## ADDENDUM #1

Reference: Browning Administration Building Remodel  
Utah Valley State College, Orem, Utah  
DFCM Project No. 08018790

## ADDENDUM NO. 1

Utah Valley State College  
Administration Building Remodel  
Orem, Utah  
DFCM Project No. 08018790

10 SOUND TRAP DETAIL  
 MDT500 SCALE: NONE

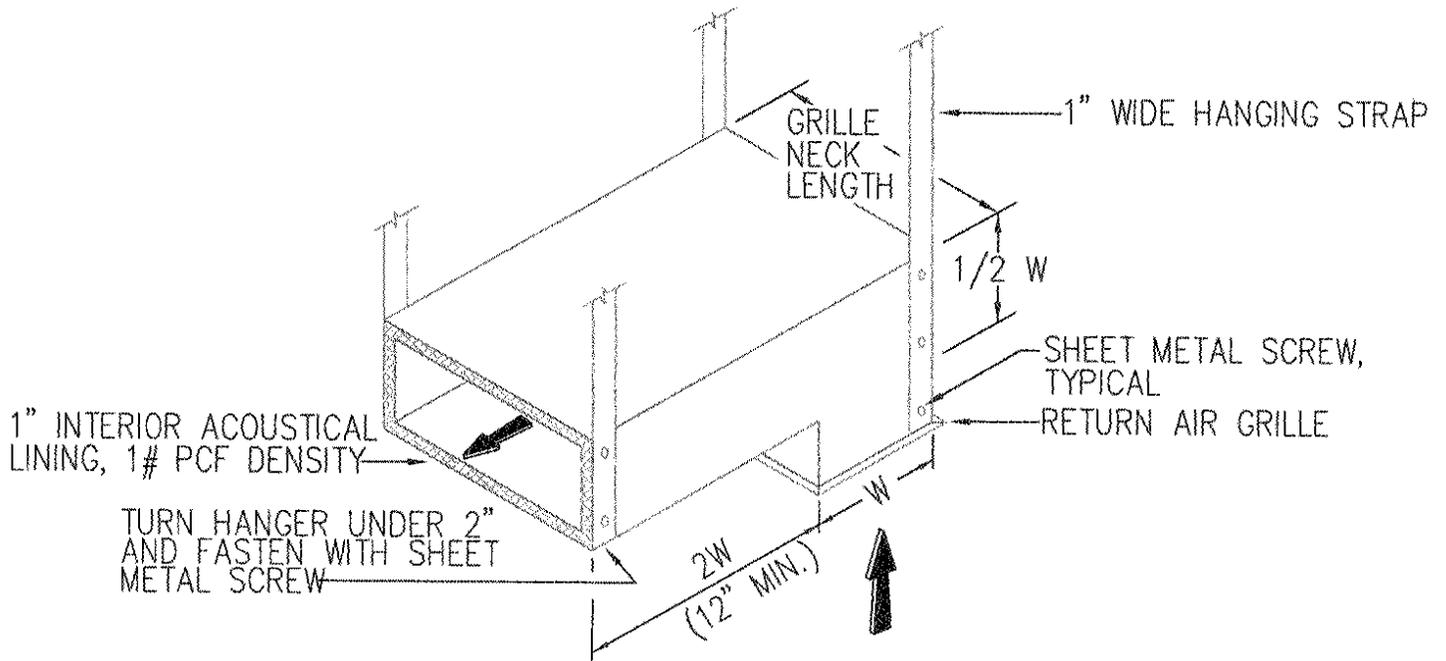
1. *Provide and install acoustically lined sound boots at each return grille location. See attached sketch SKM-HP-100 for additional information. Sound boots shall be sized to match grille neck sizes.*
2. *The large return air plenums attached to the rear of each fan coil unit shall remain, except the contractor shall cut a hole in the top of each plenum and install a Ruskin model MD-25 balance damper in the top of each return plenum. Damper mounting holes shall be reinforced with a minimum 18 ga. angle around the entire perimeter of the hole, plenum hole and damper sizes shall be as given below.*

<p>244 West 300 North, Suite 100 Salt Lake City, Utah 84103 801.534.7130 ph 801.534.1080 fax</p>	PROJECT:	SHEET TITLE:	DATE: 04/15/08	ADDENDUM
	UTAH VALLEY UNIVERSITY OREM, UTAH	PHASE I DEMOLITION PLANS	BY: BRT	1
	ORIGINAL SHEET NO:		SCALE: 1/8"=1'-0"	SHEET:
	E-DP100		JOB NO: 08-042	ESD-1

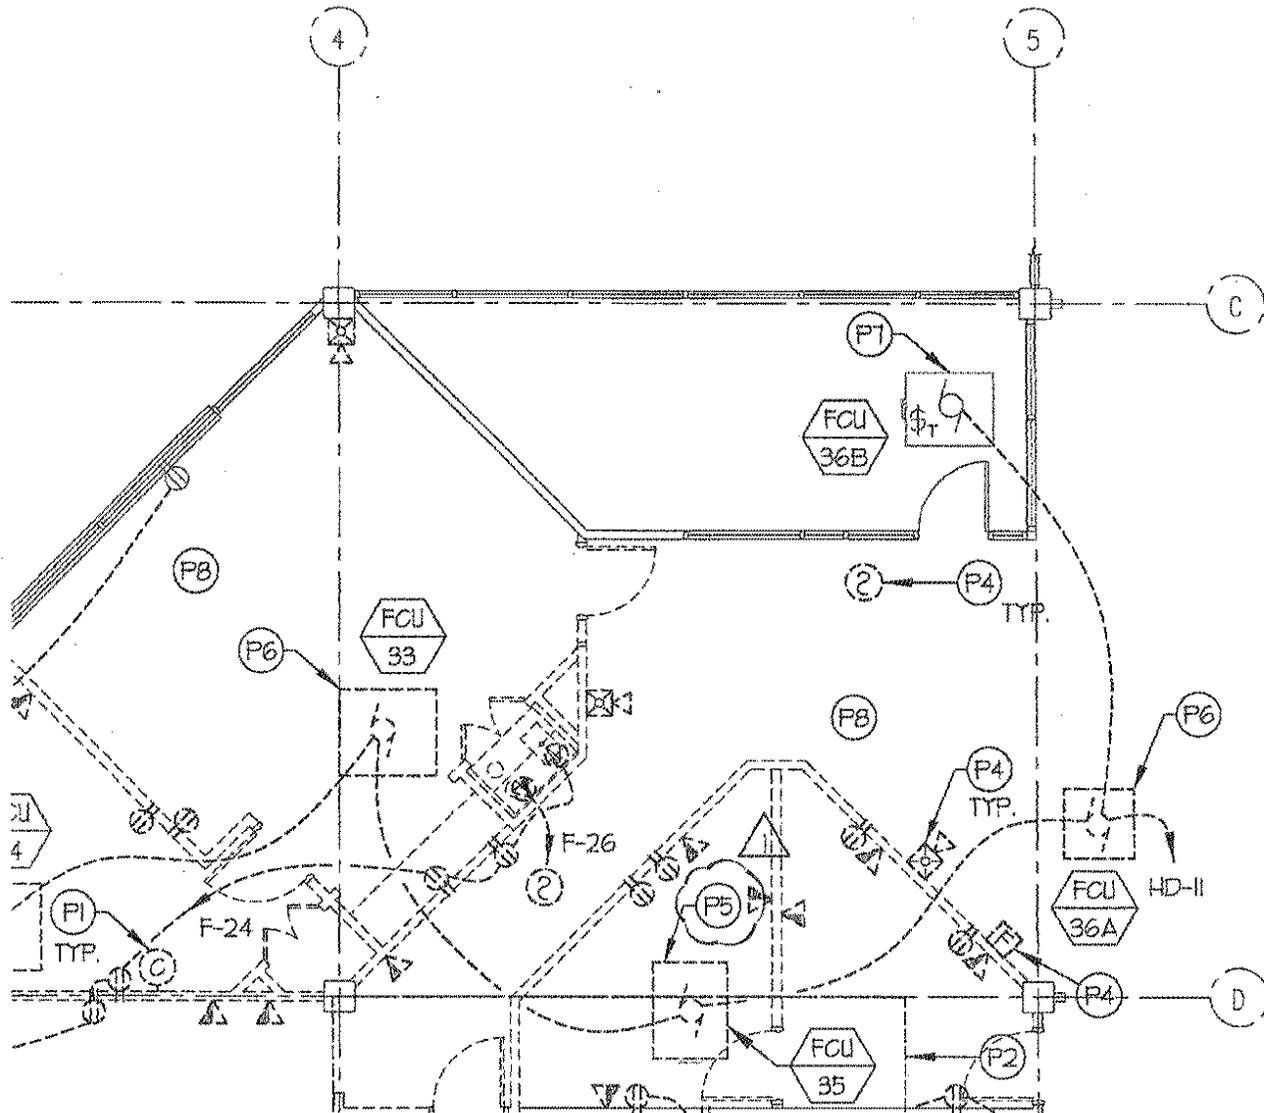
1. ESD-1 Keyed note P5 has been modified and the keyed note for FCU-35 has been corrected.

- (P5) EXISTING FAN COIL UNIT TO BE RE-LOCATED. REFER TO E-EP100 FOR NEW LOCATION. EXISTING CIRCUIT TO BE RE-USED. ALL ELECTRICAL ITEMS ASSOCIATED WITH THE FAN COIL UNIT TO INCLUDE BUT ARE NOT LIMITED TO STARTER, DISCONNECT, LOW VOLTAGE TRANSFORMER ARE TO BE RE-USED IF IN SATISFACTORY CONDITION.

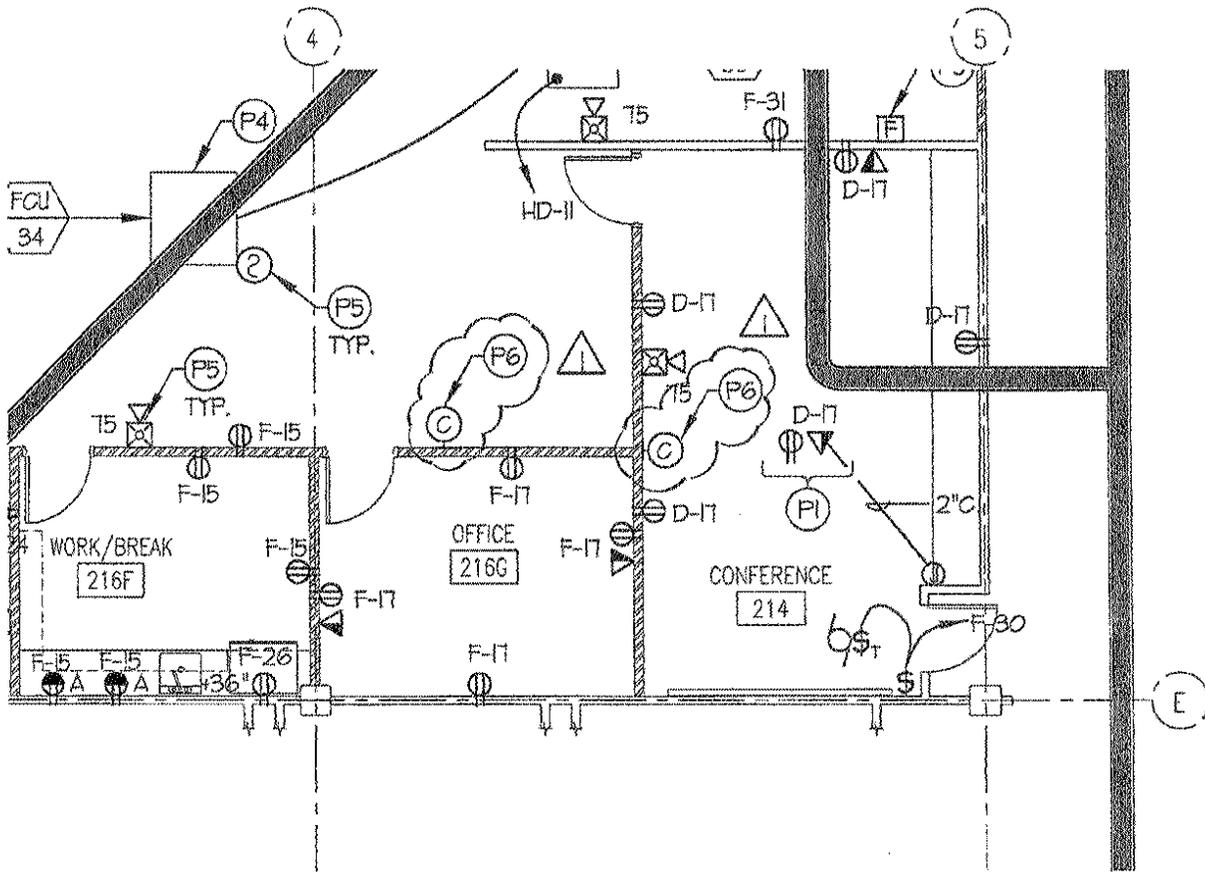
1. ESD-2 includes Keyed note P6 and the location of the system clocks.
2. ESD-3 includes the switch designation for the track lighting and the Keyed note L1 for the existing occupancy sensor in a new location.

⚠ (P6) CONFIRM NEW LOCATION OF CLOCK WITH OWNER PRIOR TO ROUGH-IN.
